NO. SI D4-183

Technify Motors Service Bulletin 125-1019 P1 Rev. 1
ATA-Code: 81-00

Service Bulletin No. / Date: SB TMG 125-1019 P1, Revision 1 / September 15, 2015

Subject: Integral Exhaust Manifold

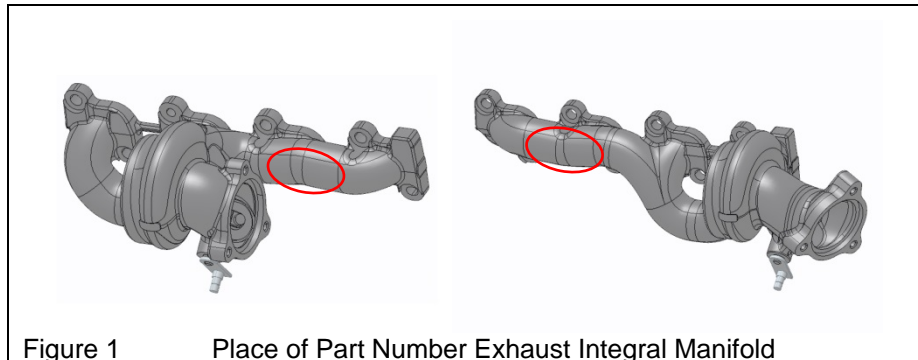
If the engines have Exhaust Integral Manifold
P/N 05-7241-K0176xx or P/N 05-7241-K0178xx
See Figure 1.

Installation of exhaust integral manifold P/N 05-7241-K023801 or P/N 05-7241-K023901 in accordance with RM-02-02, Chapter 72-40.03, Issue 3, Revision 2 or later approved revisions.

Installation of exhaust integral manifold P/N 05-7241-K023801 or P/N 05-7241-K023901 in accordance with RM-02-02, Chapter 72-40.03, Issue 3, Revision 2 or later approved revisions and turbocharger P/N 05-7241-K018703, 05-7241-K020302 or 05-7241-K019402 in accordance with RM-02-02, Chapter 72-40.01, Issue 3, Revision 1 or later approved revisions.
